Southern A&E, LLC
 7951 Troon Circle
 Austell, Georgia 30168
 (770)-819-7777

Project Name: **New Addition To:
 Harper Elementary School**
 Project Number: **01-606-031**
 Client **Clayton County Schools**
 City/State **Jonesboro, Georgia**

Addendum Date: July 29, 2009
Pre-Bid Mtg Date: July 22, 2009
Bid Date: August 11, 2009

END OF ADDENDUM NO. 1
01-606-031

TITLE: REVISED PARTIAL PLAN - MEZZANINE LEVEL PLAN

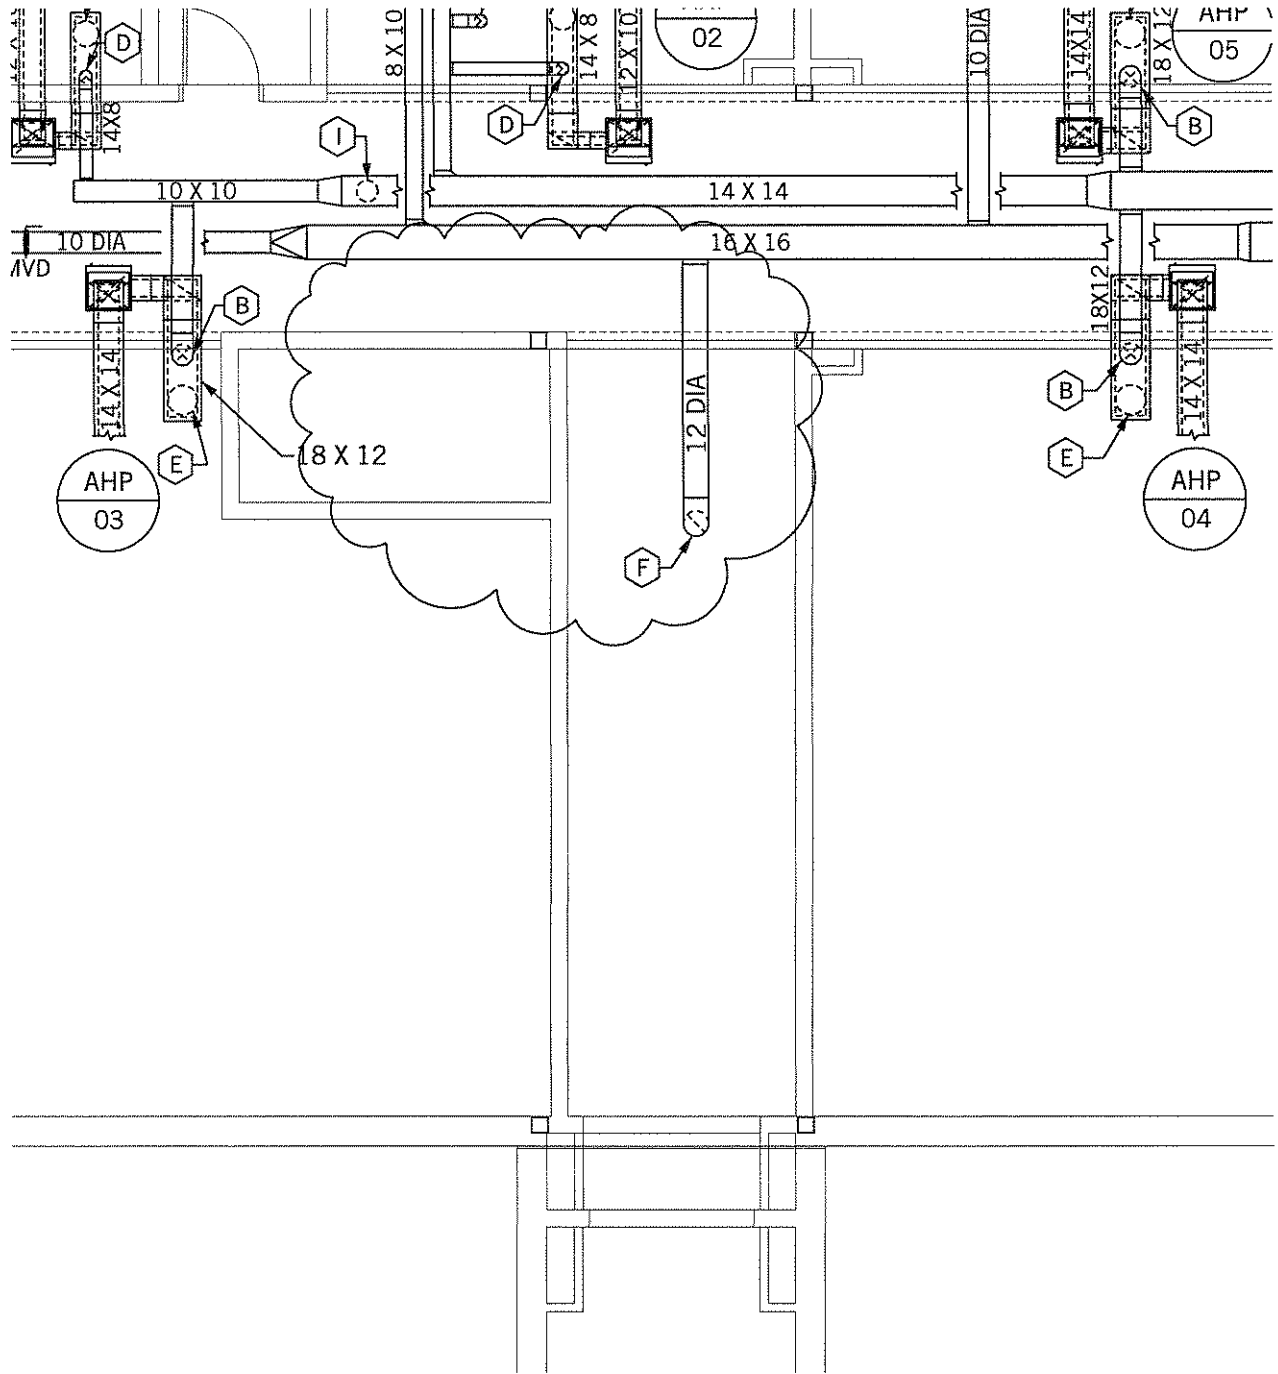
- c. Revise keyed notes for classroom addition floor plan G10/M2 as shown on supplemental drawing M2.S2.AD1.
 - d. Revise mezzanine floor plan to delete exhaust duct in Electrical 317 and add exhaust duct down into corridor as shown on supplemental drawing M2.S3.AD1.

TITLE: REVISED WING A - POWER PLAN

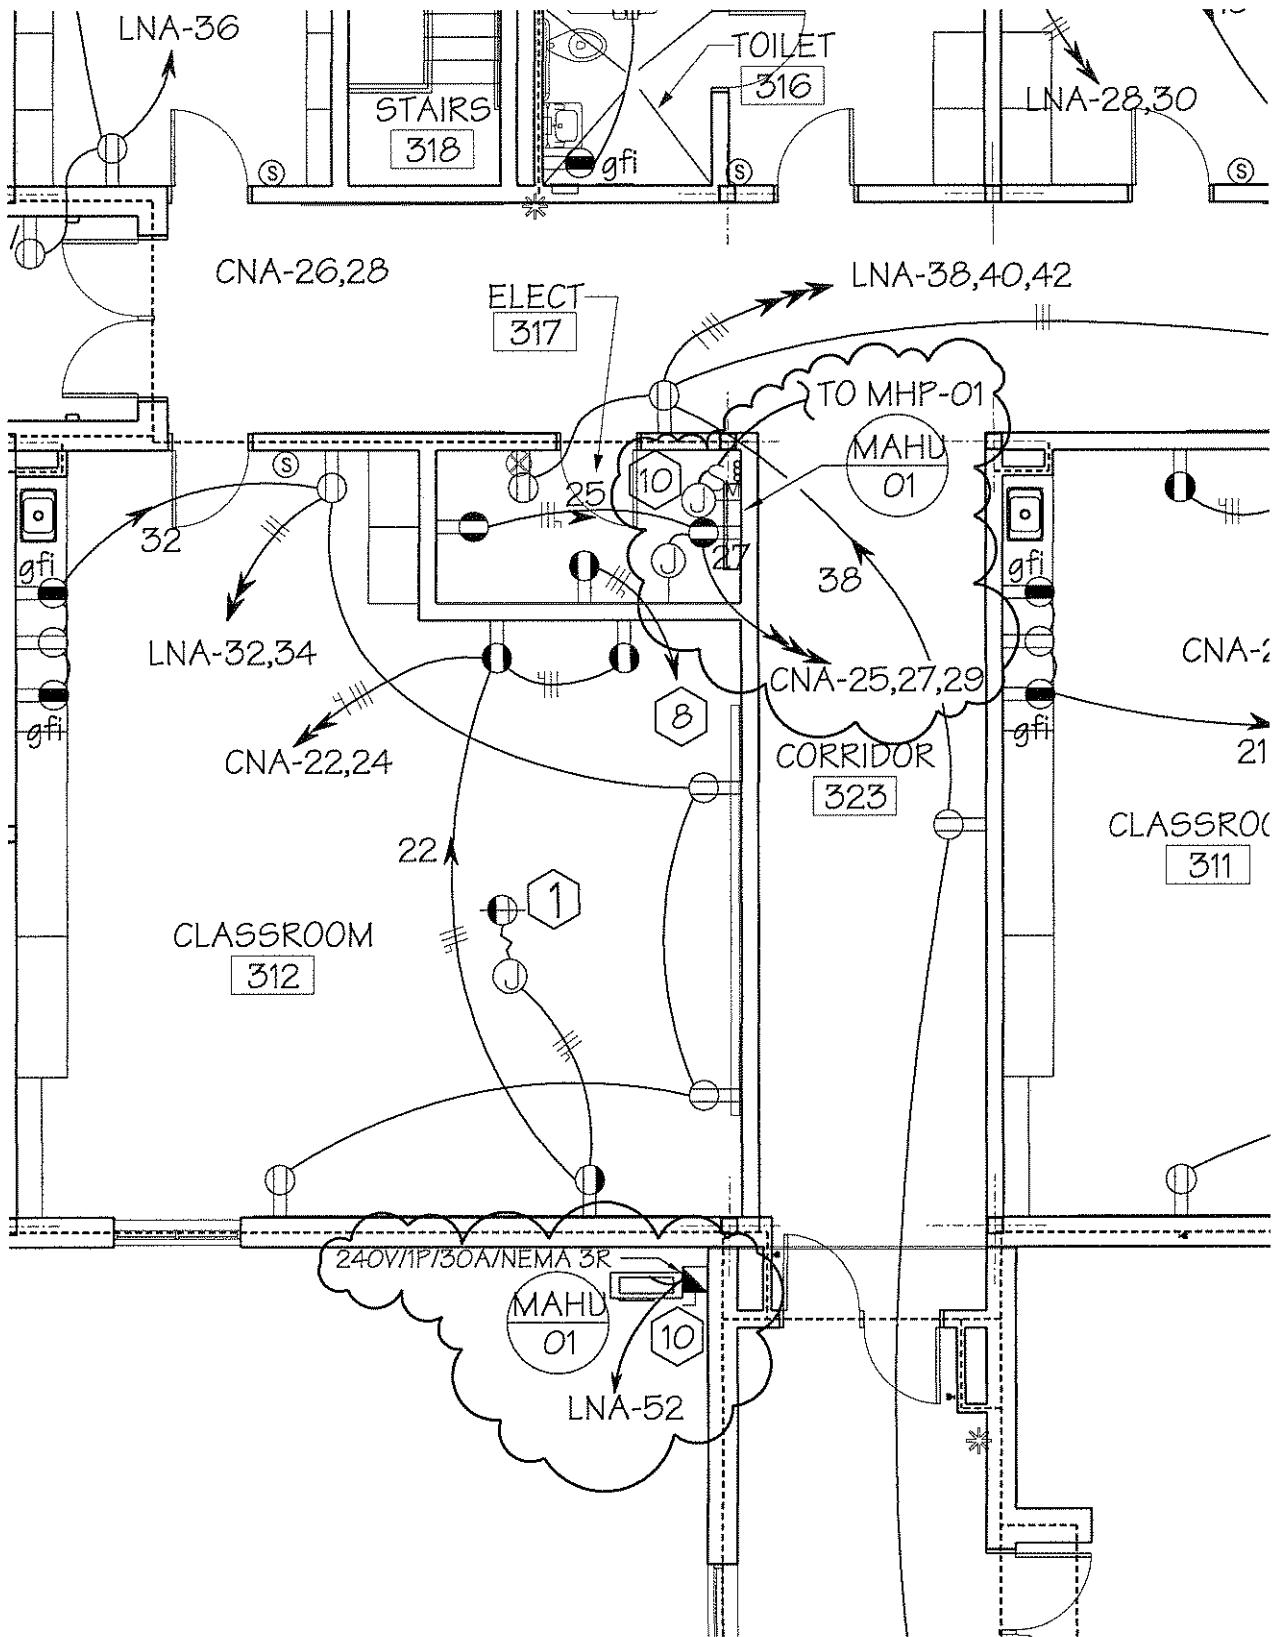
- b. Classroom 309
 1. Change lighting circuit reference from #7 to circuit #9 to correspond to with panel schedule.
6. Drawing E4
 - a. Revise Wing A - Power Plan to include power and control raceways for new mini-split air conditioning system (MAHU/MHP-01). Refer to attached supplemental drawing E04.S1.AD1.

TITLE: SUPPLEMENTAL DETAILS

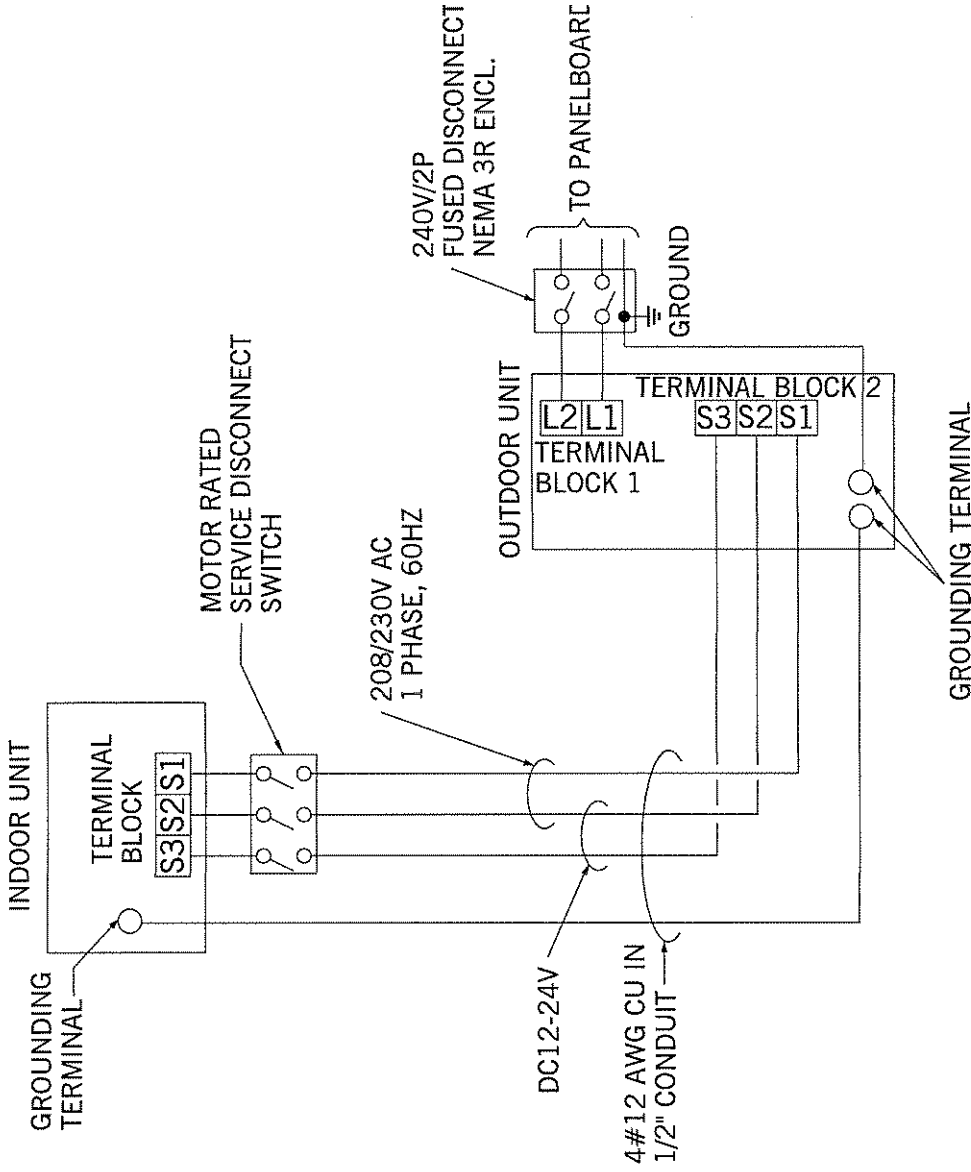
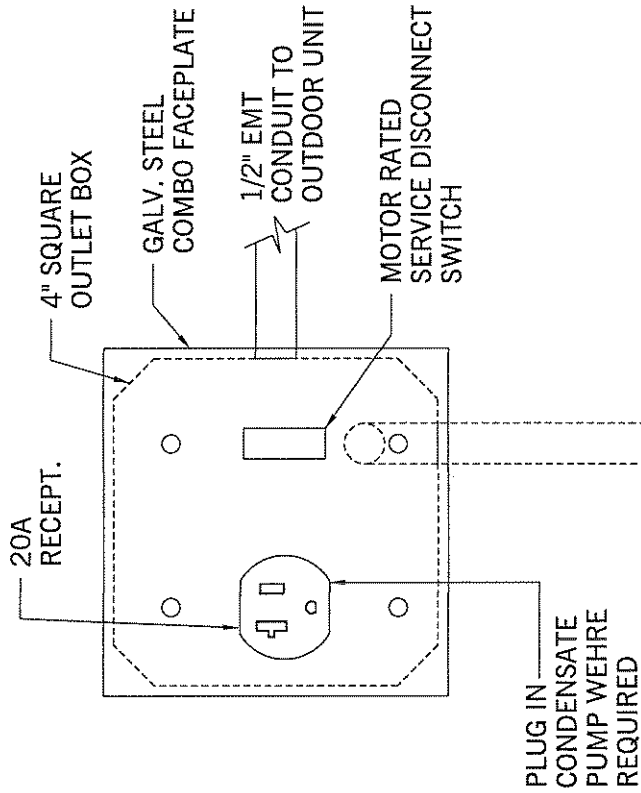
- b. Add note #10 to Power Plan Notes as follows:

"10. FURNISH AND INSTALL MINI-SPLIT WIRING AND CONDENSATE PUMP CONNECTION PER MINI-PLIT WIRING SCHEMATIC AND MINI-SPLIT INDOOR UNIT / CONDENSATE PUMP CONNECTION DETAIL."

- b. Add "MINI-SPLIT INDOOR UNIT / CONDENSATE PUMP CONNECTION DETAIL" and "MINI-SPLIT WIRING SCHEMATIC" detail as shown on attached supplemental drawing E08.S1.AD1.
